Product Change Notice (PCN)

PCN Number: **PCN-0450921R-01**

SJ-43514-SMT-TR, SJ-43515RS-SMT-TR, SJ-43515TS-SMT-TR, SJ-43516-SMT-TR, SJ-43516-SMT-TR-BE, 43516-SMT-TR-GR, & 43516-SMT-TR-PI

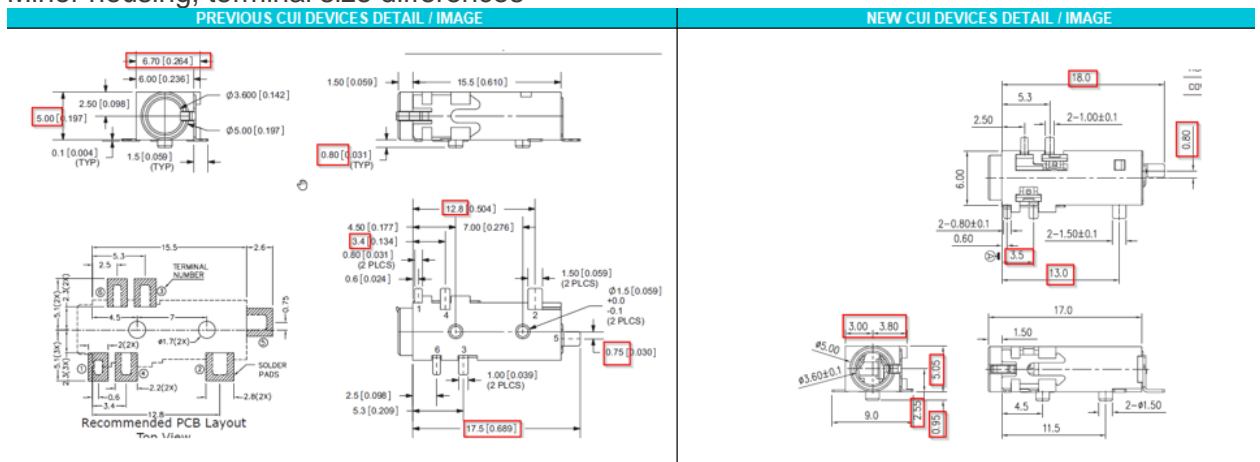
Reason(s) for Change: *Manufacturing process improvements*

1. Minor housing, terminal size differences

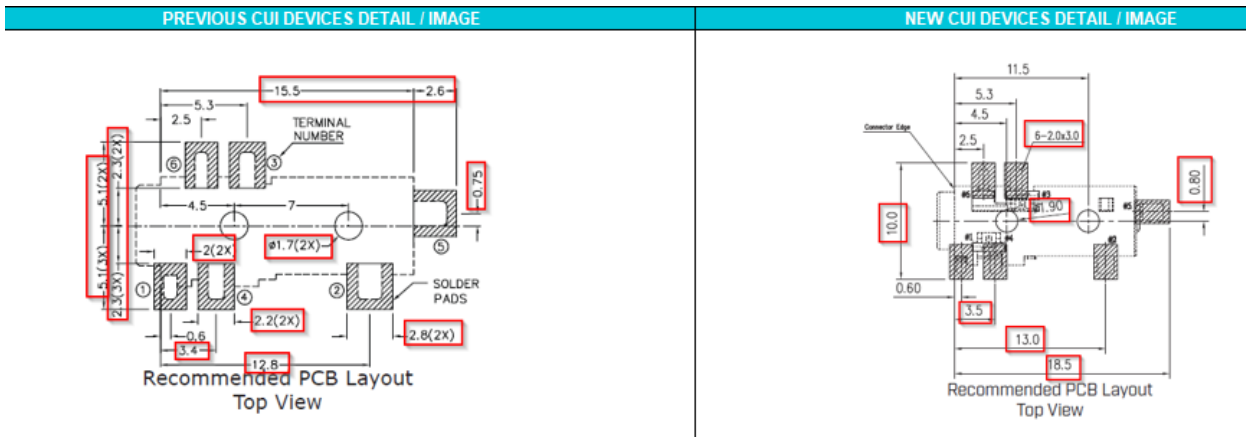
2. PCB size differs
